DNDEN00369A

CONSTRUCTION DOCUMENTS

DISH WIRELESS PROJECT INFORMATION
**US-CO-5035
FOUNTAIN
82 WIDEFIELD BLVD.
COLORADO SPRINGS, CO.
80911**

SHEET NUMBER
T-1

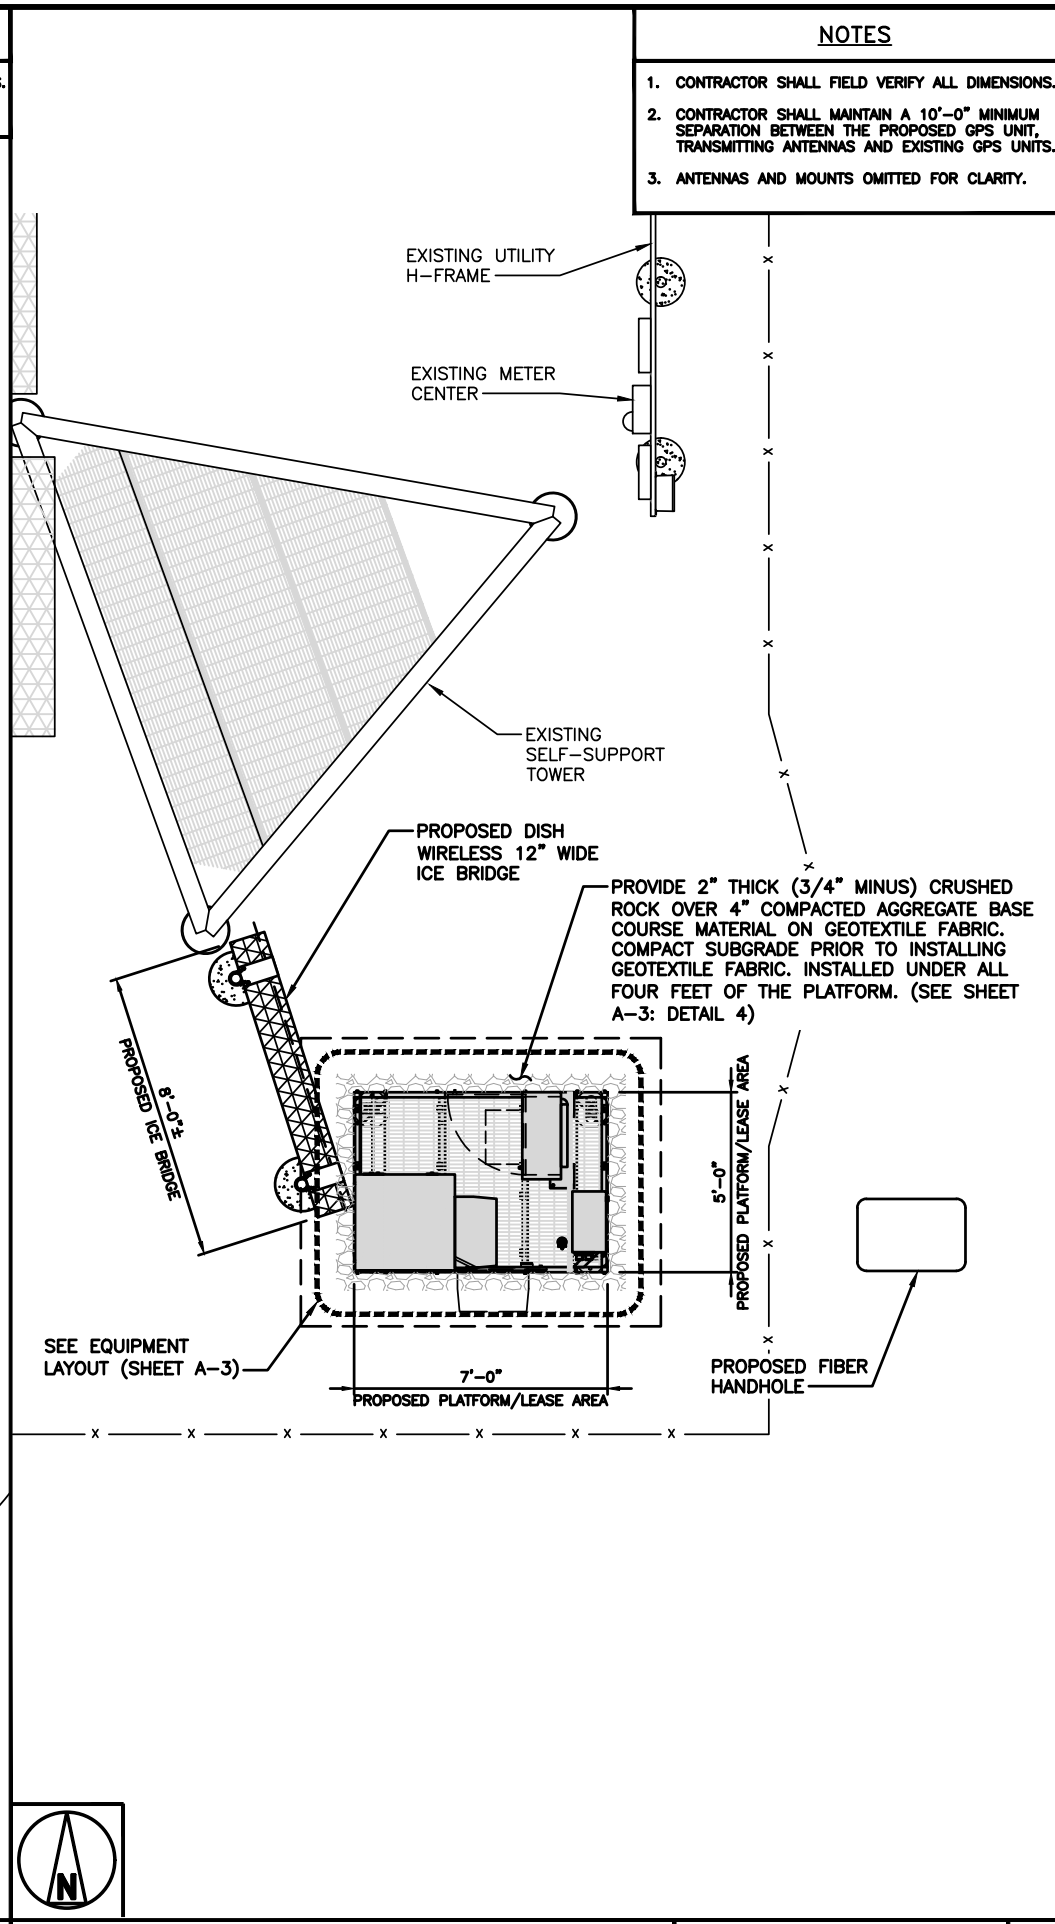
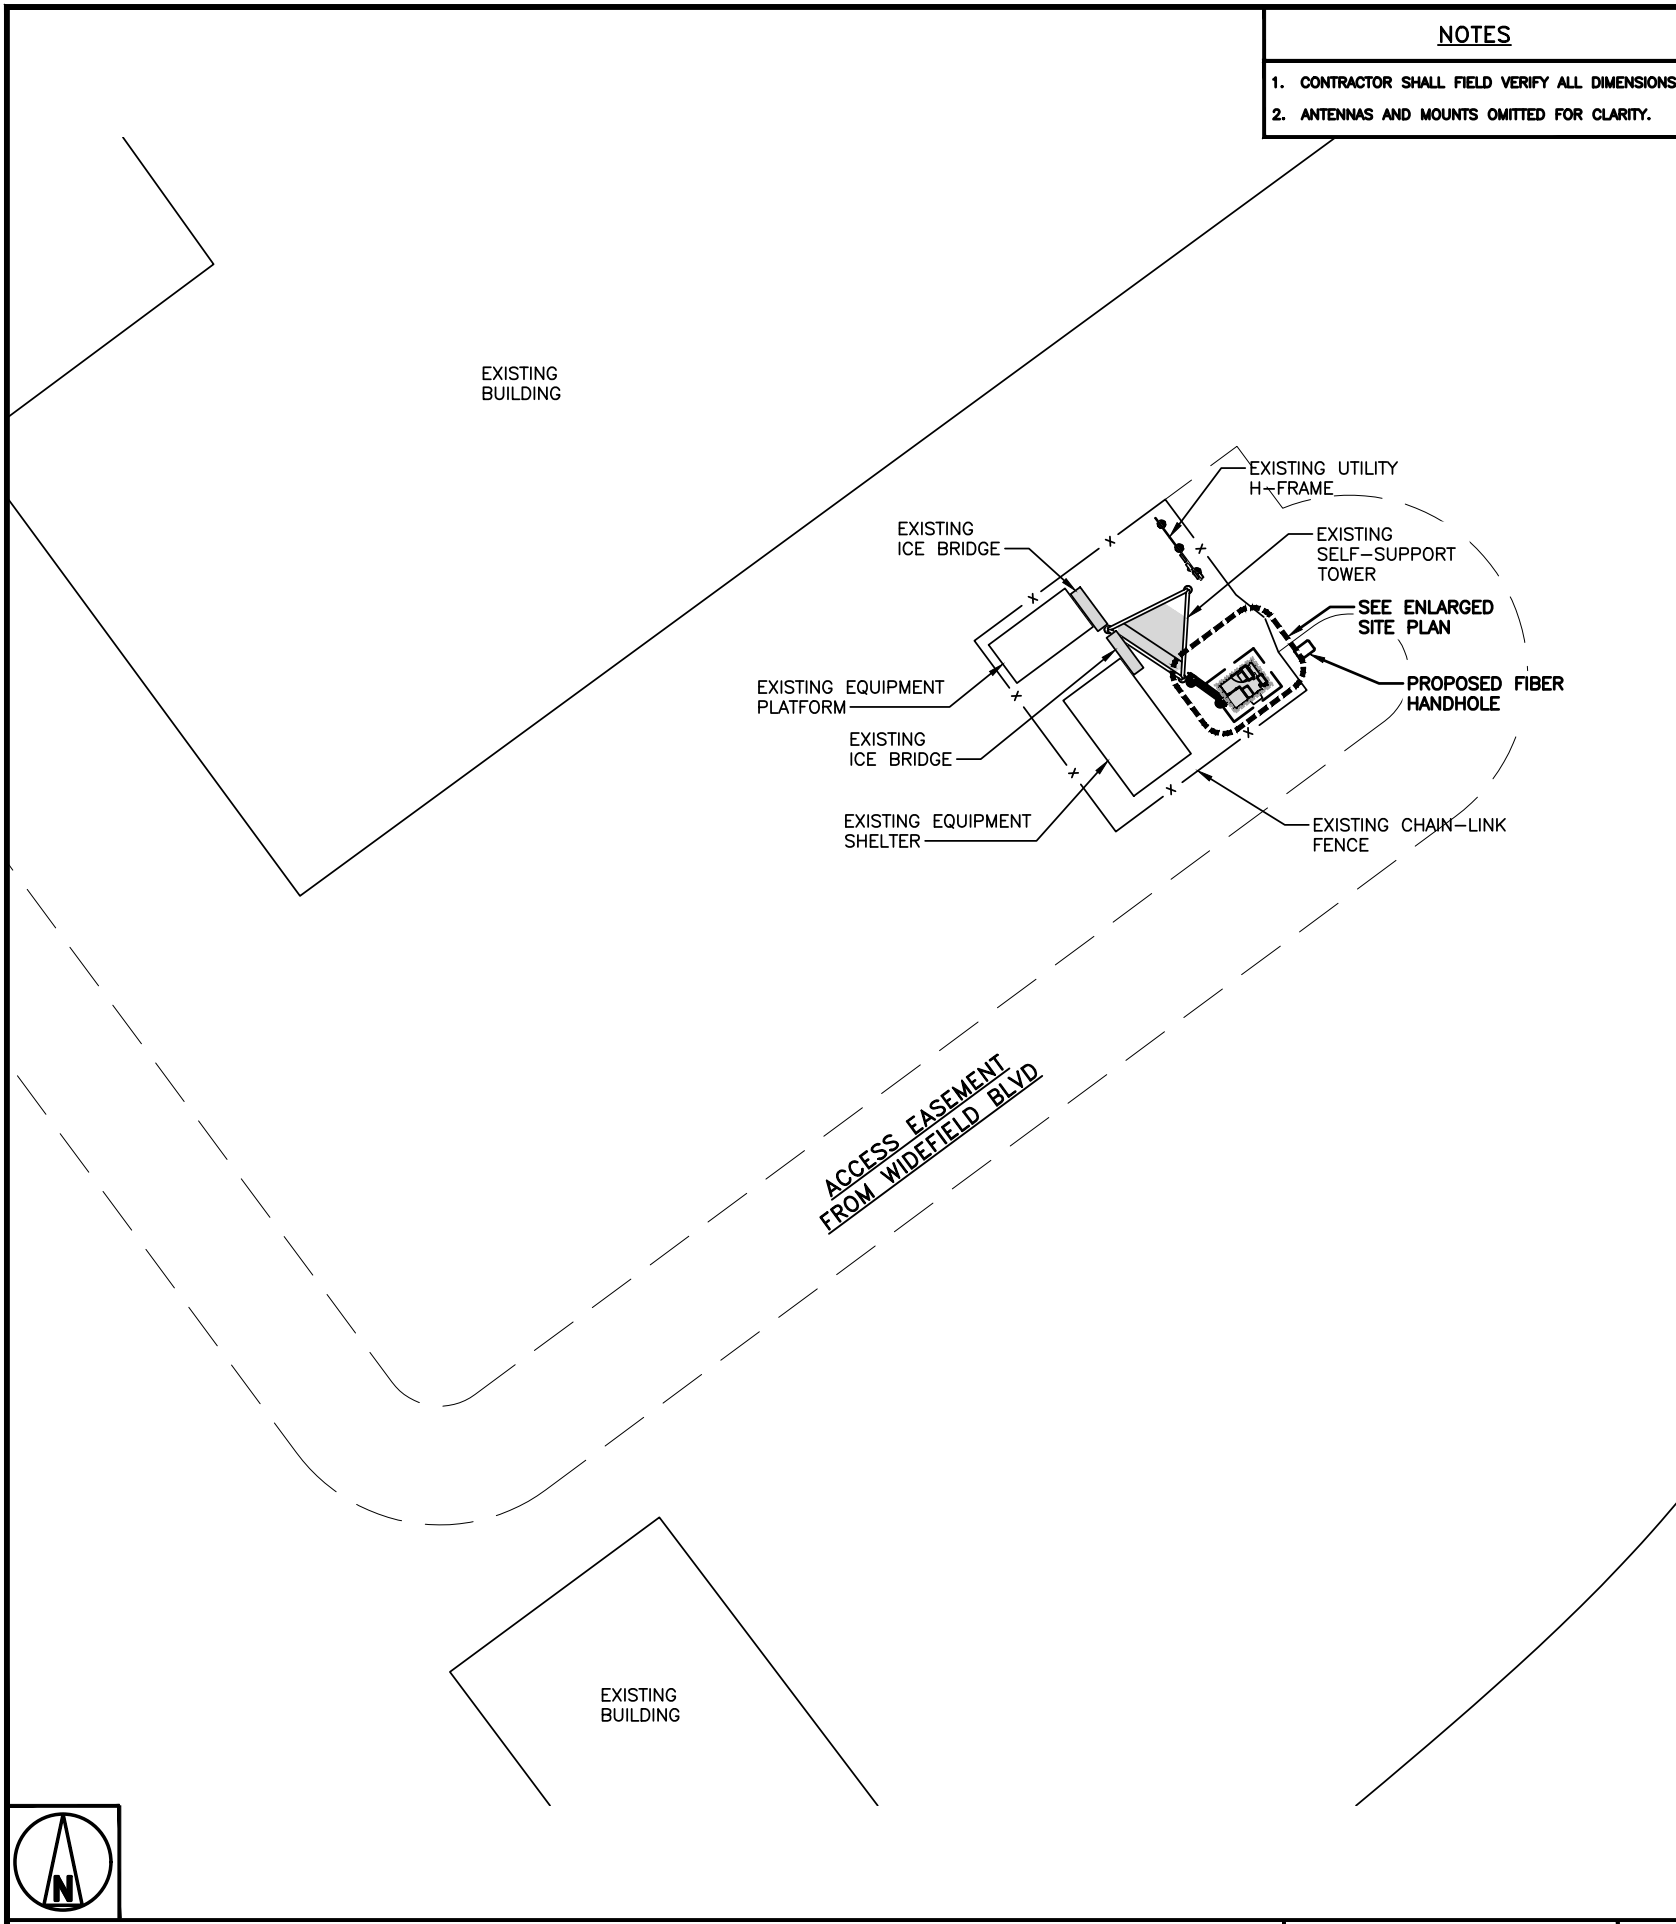
Please add the following:

- Owner name, contact telephone number, and email for responsible party
- Plan preparer name, telephone number, and email
- Property tax schedule number
- Legal description
- Lot/parcel size
- Lot area coverage calculation
- Existing zoning
- Total gross building square footage
- Vicinity map showing the subdivision in relation to section lines and existing or proposed arterial or collector roadways.

Please add "PCD File No. TWR-21-007".
